A Review of the South Texas Project Probabilistic Safety Analysis for Accident Frequency Estimates and Containment Binning

Prepared by
T. A. Wheeler, J. L. Darby, J. A. Lambright
T. T. Sype, B. Walsh

Sandia National Laboratories
Operated by
Sandia Corporation

Prepared for
U.S. Nuclear Regulatory Commission

REACTOR DECAY HEAT
SOUTH TEXAS PROJECT
UNITS 1 & 2
Figure 6.2.1.1-18 Revision 0

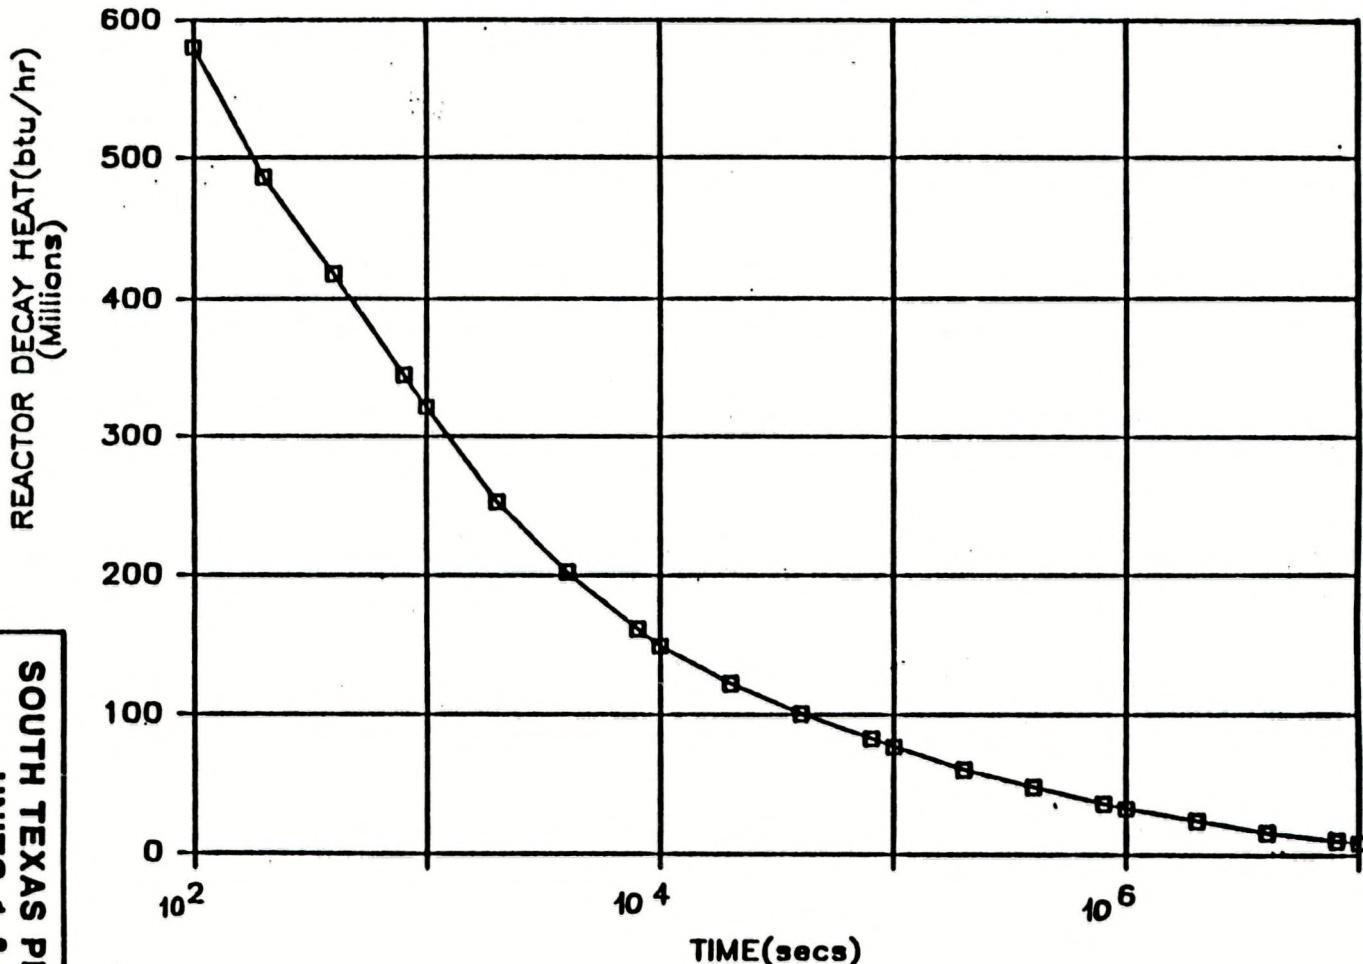
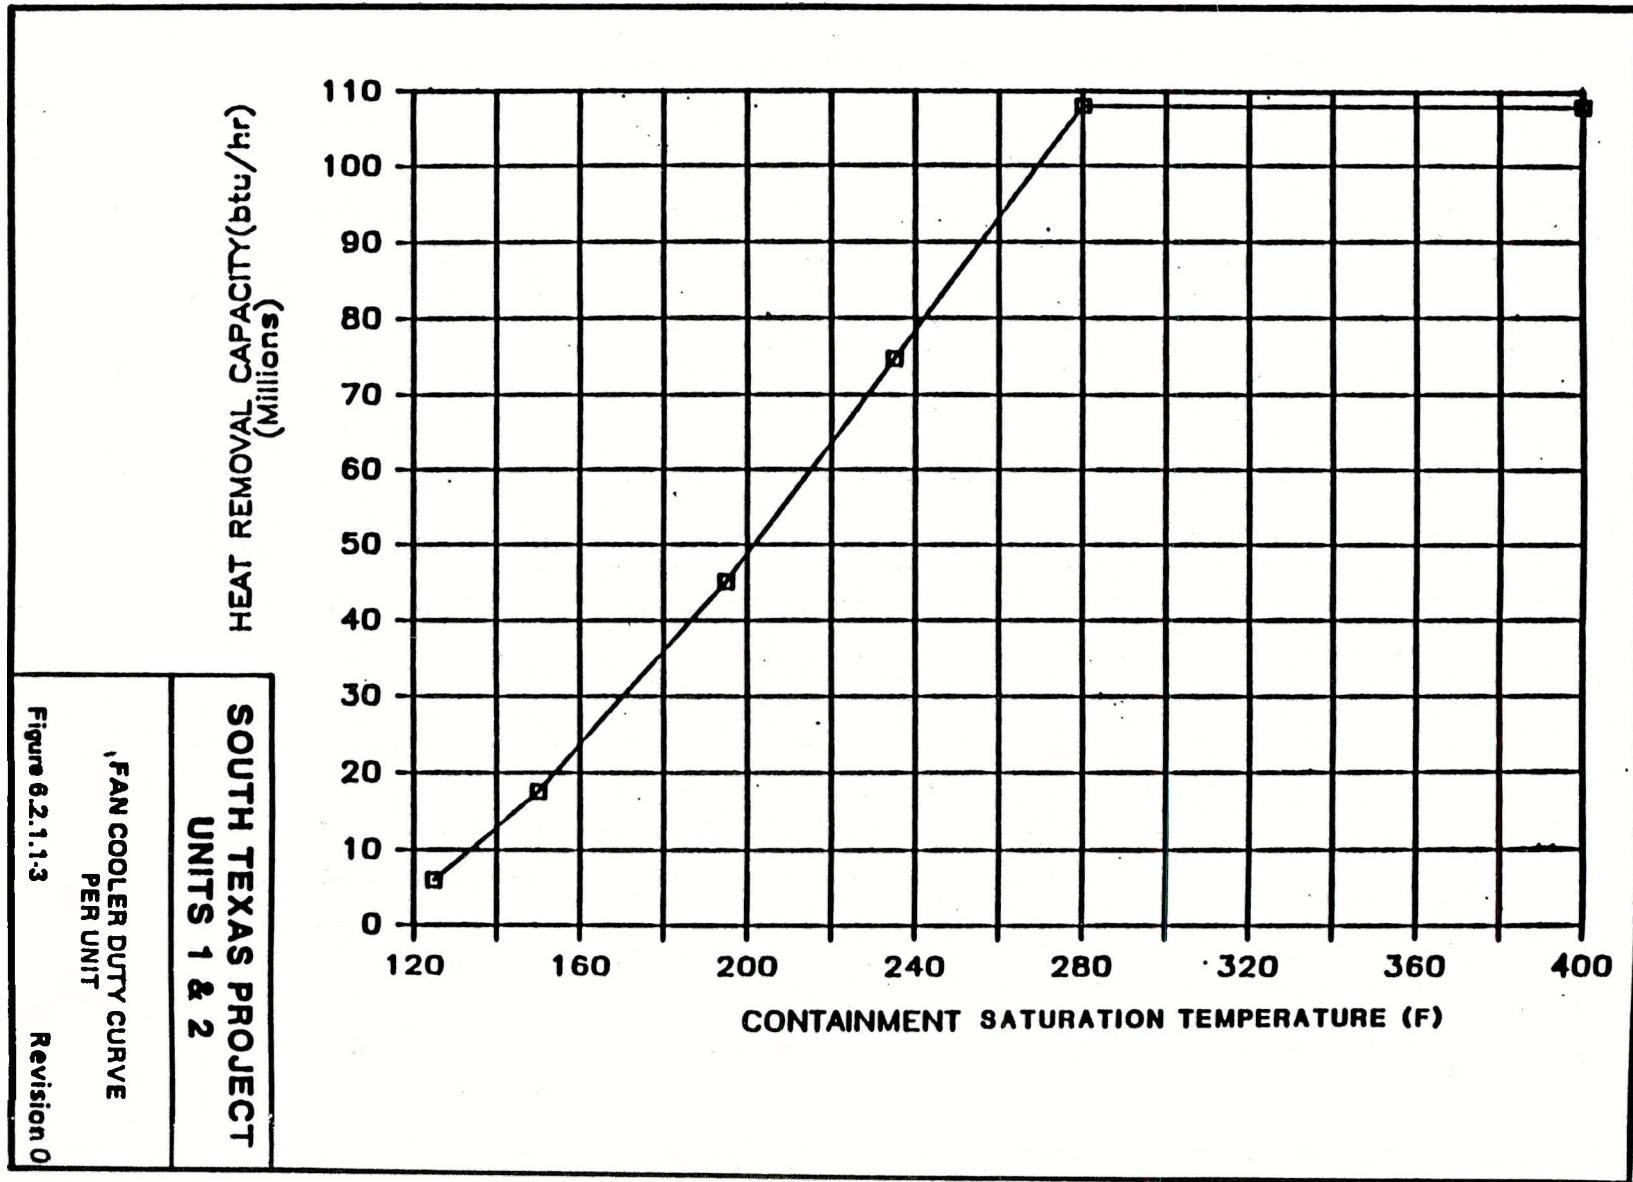
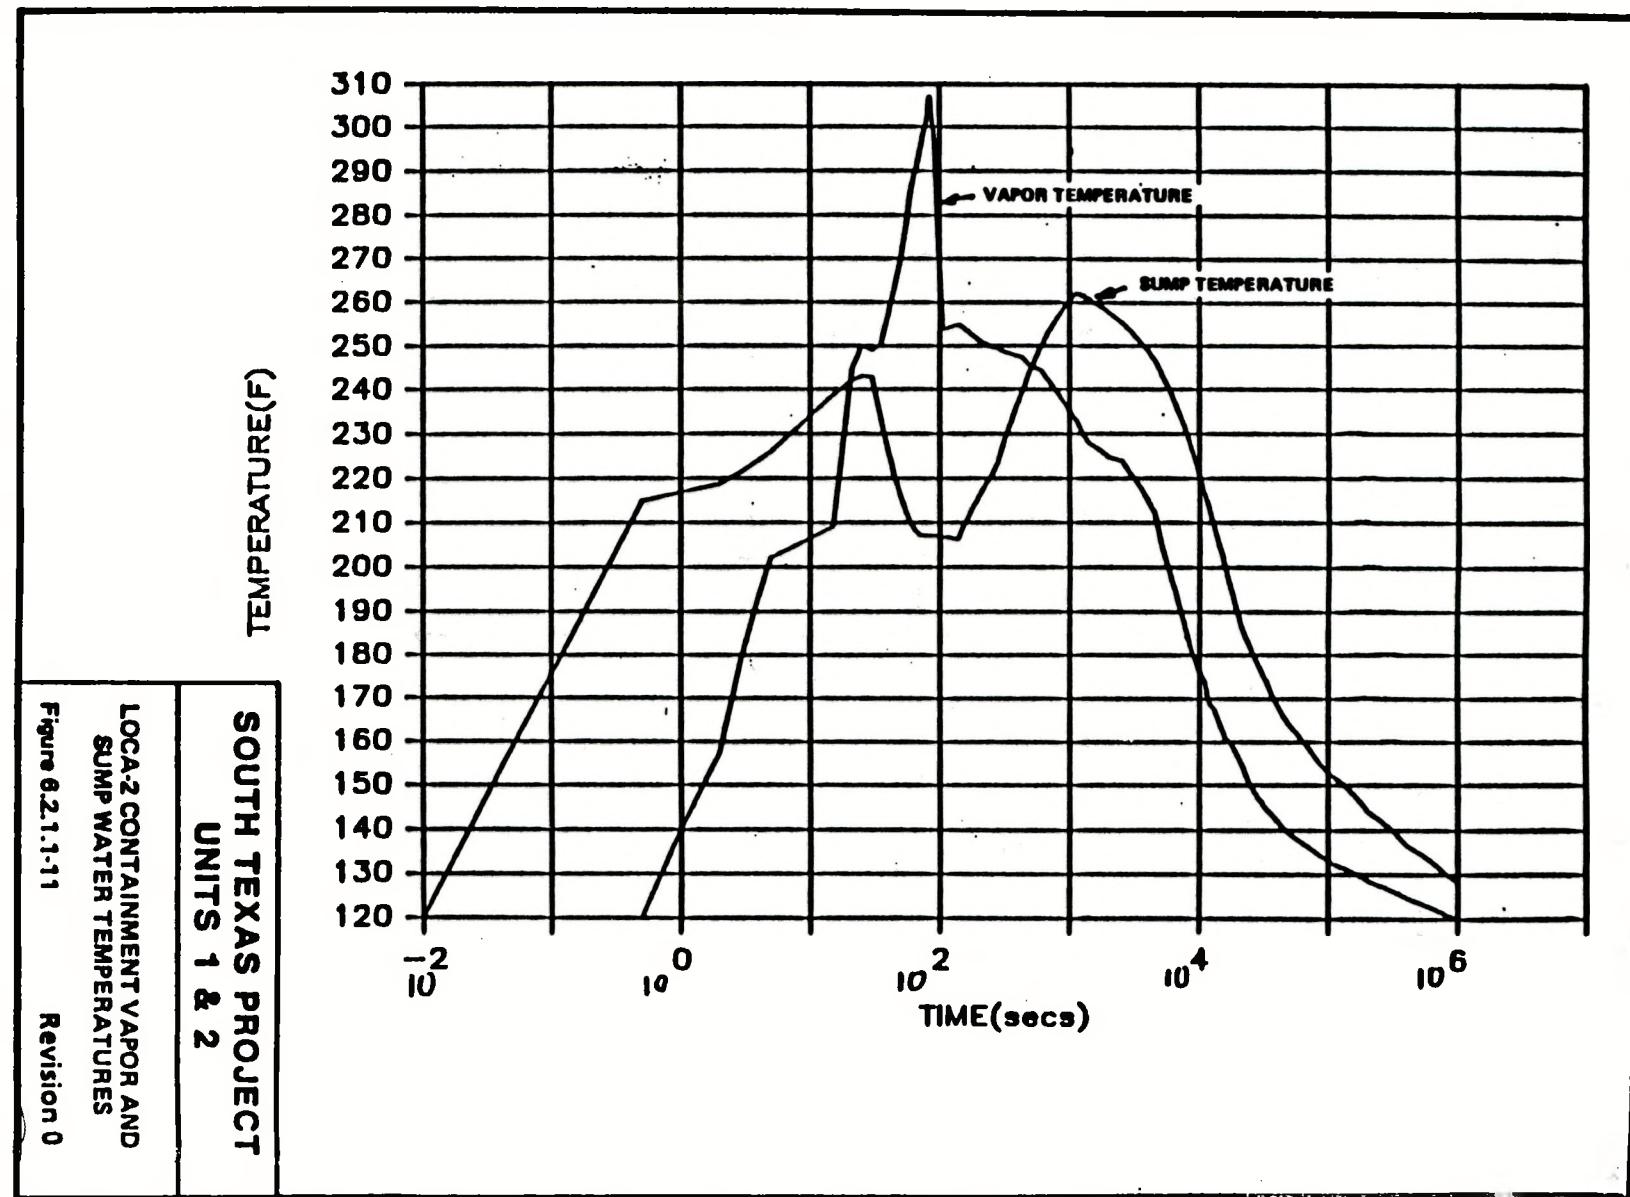
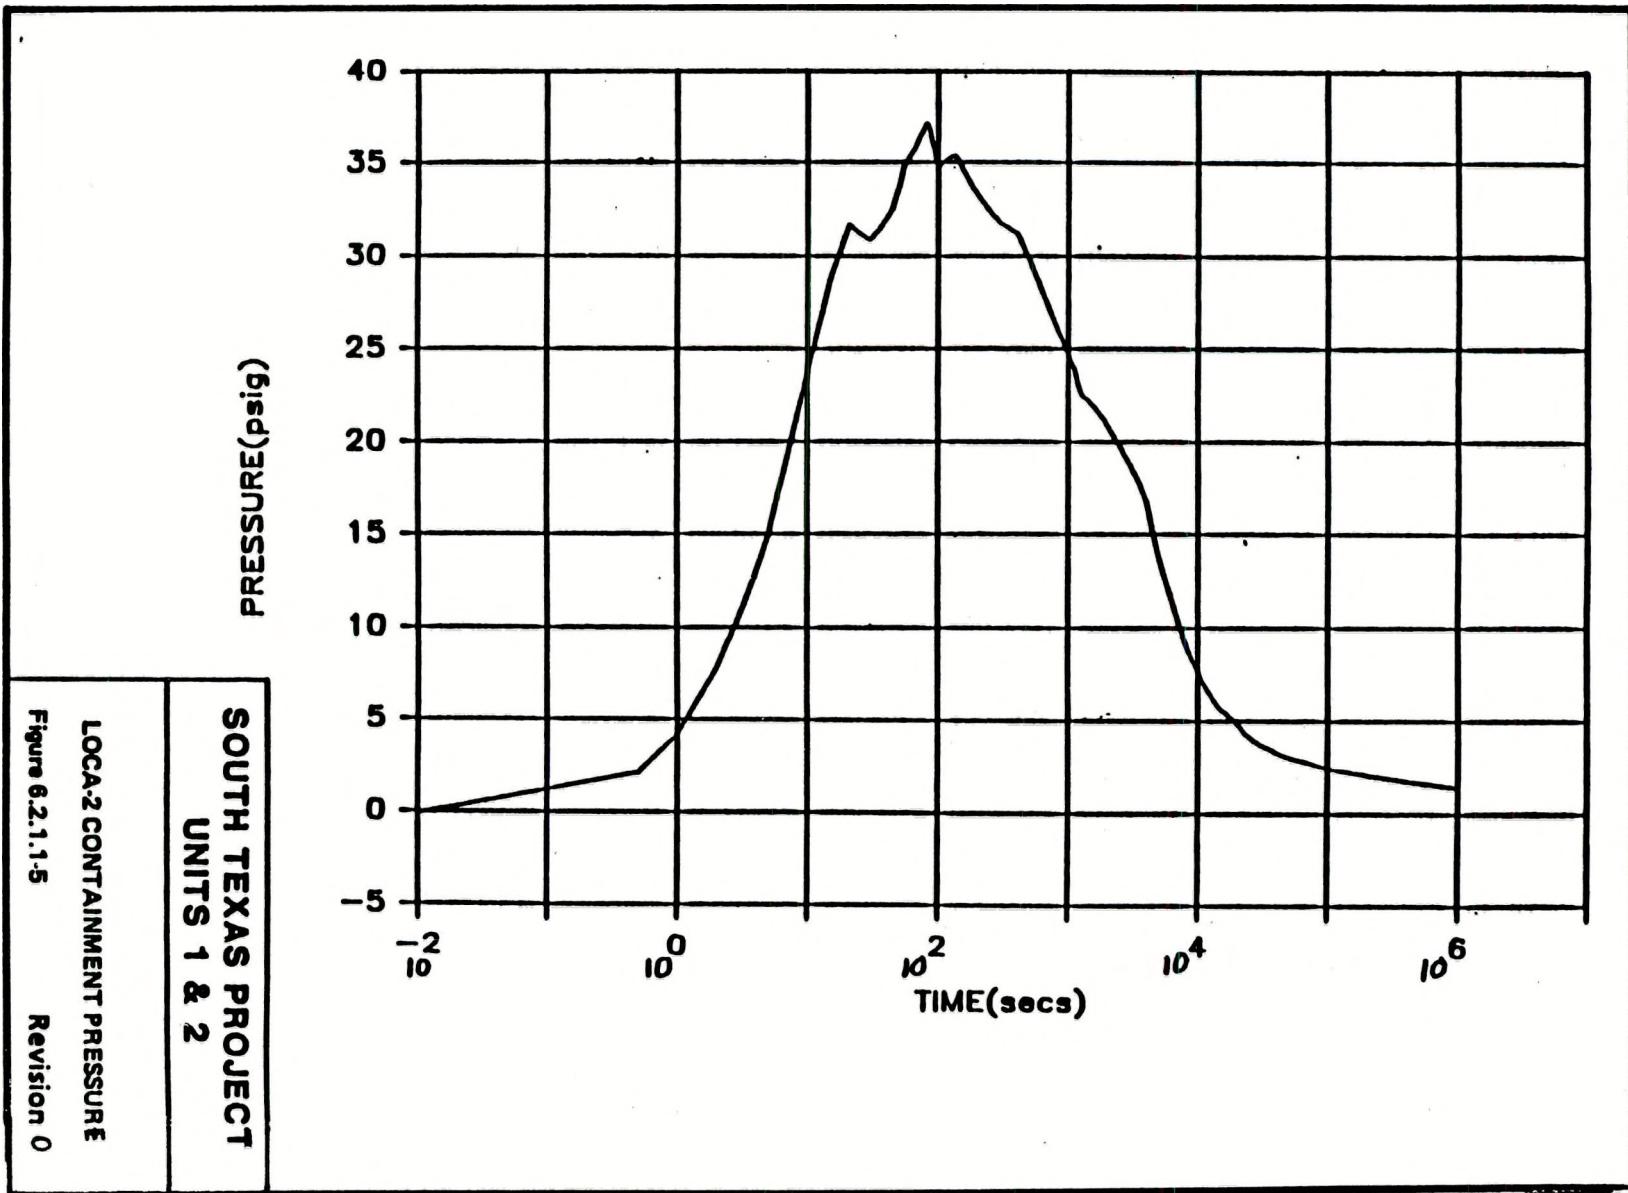
The decay heat from the reactor would not reach the lower heat removal rate for these two performance specifications (200×10^6 Btu/hr) until 4000 s after reactor trip [Reference 2, Figure 6.2.1.1-18]. If it is assumed that recirculation cooling is initiated at 1200 s after reactor trip (a reasonable time based on information in the FSAR), then the containment conditions at the start of recirculation would be 235°F with a decay heat rate of 280×10^6 Btu/hr [Reference 2, Table 6.2.1.1-10 and Figure 6.2.1.1-18]. There would be an increase of heat in the containment for the next 2800 s. If this mismatch is conservatively assumed to be 80×10^6 Btu/hr, a total of 62×10^6 Btu would be added to the containment before the heat removal rate of the containment systems would equal the decay heat rate. This buildup would be acceptable because 190×10^6 Btu would be required to increase the atmospheric temperature of the containment from 235°F to 280°F with saturated steam.

As indicated by the SNL reviewer, and referring to the attached figures from the STPEGS UFSAR, core decay heat generation at approximately 4000 seconds (Figure 6.2.1.1-18) is approximately 200×106 BTU/hr.

It can be seen from Figure 6.2.1.1-3 that the heat removal rate of two RCFCs at 280°F is approximately 220×106 BTU/hr. If it is assumed that recirculation is initiated at 1216 seconds which is the case for the design basis LLOCA (Table 6.2.1.1-10), decay heat injection at that time is approximately 300×106 BTU/hr and containment and sump vapor temperatures are as shown in Figure 6.2.1.1-11 (approximately 235°F and 260°F respectively). Reference to steam tables indicate that containment vapor temperature and pressure increase due to the excess decay heat injection over removal rate during this period will not result in exceeding design containment pressure of 71.2 psia. Subsequently, decay heat injection is exceeded by the RCFC removal rate.

FIGURE 11.3-14. COMPOSITE CONTAINMENT FAILURE PROBABILITY DISTRIBUTIONS FOR BENIGN FAILURE, GROSS FAILURE, AND TOTAL FAILURE

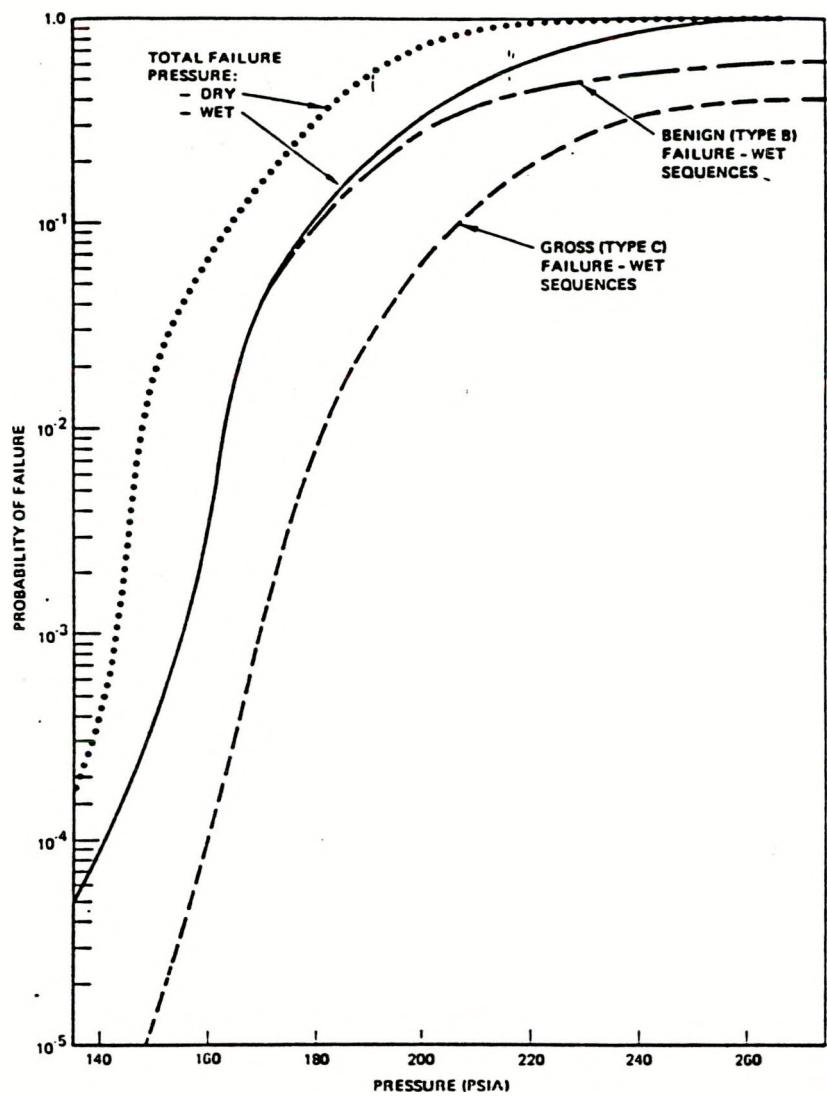
It is claimed in the PSA that a hole in containment greater than or equal to three inches in diameter will not allow the containment to pressurize. [Reference 1, Page 5.4-73.] The basis for this claim is not clear. At a design pressure of 71.2 psia, a three-inch hole will relieve about 2.2×10^4 lb/hr of saturated steam [based on equations in Reference 13]. If it is assumed that all decay heat generates steam and an enthalpy of phase change of 900 Btu/lb is used, this relief rate can match 1.98×10^7 Btu/hr of decay heat. However, this level of decay heat is not reached until about 10^6 seconds after reactor trip [Reference 2, Figure 6.2.1.1-18]. The PSA does not justify the three-inch limit. In item IE11 of Appendix 3, HLP indicated that the three inch limit is based on using an estimated failure pressure of 150 psia instead of the design pressure of 71.2 psia. By the time 150 psia is reached the decay heat is

- the probability of gross containment failure for wet sequences at 150 psia is less than 10^{-4} (Figure 11.3-14)
- at 21-22 hours after shutdown, a 3-inch diameter hole will prevent pressurization beyond 150 psia for wet sequences (Figure 11.3-1)
- at 24 hours after shutdown for the TE sequence, containment pressure is about 145 psia (Figure 2.2.4-1A)

050053 (03/88)	CALC NO. MC 6182	SHT 17A OF 21
SOUTH TEXAS PROJECT ELECTRIC GENERATING STATION HOUSTON LIGHTING & POWER	REV. 0	PREPARER/DATE 1985 5/17/90
GENERAL COMPUTATION SHEET		REVIEWER/DATE J.R.P. 5/23/90
SUBJECT PD Pump Run HT up UNIT/s 182

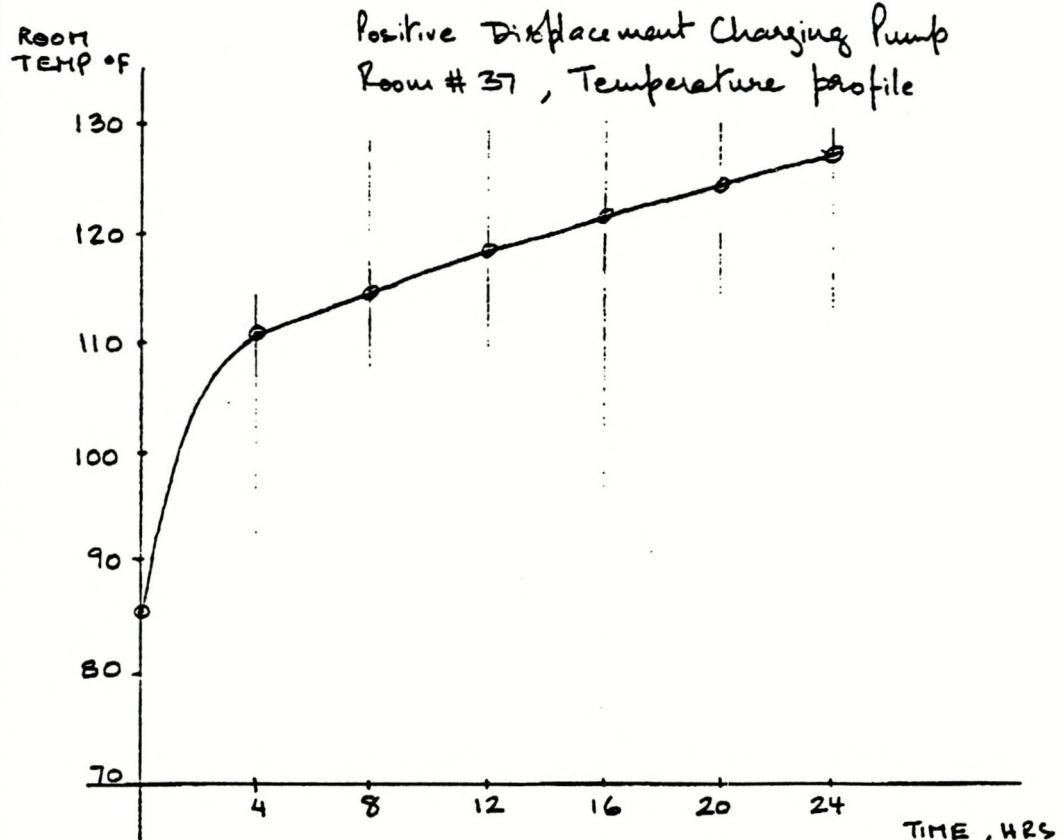
System Description 10 for safety injection, assumption J-2, states with respect to ECCS pump room cooling "...it is assumed that room cooling is not necessary due to natural convection that will be available. [1]" This assumption is not justified. During the November 1989 site visit, HL&P stated that they are investigating this issue. [5] During a tour of the plant in November, it was noted that the ECCS pump rooms are open to the Fuel Handling Building. Also, the RHR heat exchangers are inside containment, not in the ECCS pump rooms as they are at some plants. Thus, heat removal requirements for these rooms may be possible by natural circulation alone but this claim must be substantiated.

A calculation has been completed to determine the impact of loss of room cooling in the PDP pump cubicle. The study indicates that the room temperature in the cubicle is approximately 115°F at the end of eight hours (see attached temperature profile). No credit is taken for mixing with outside air. This calculation is the basis for the assumption that the PDP can be operated with loss of room cooling under station blackout conditions with the TSC diesel available.
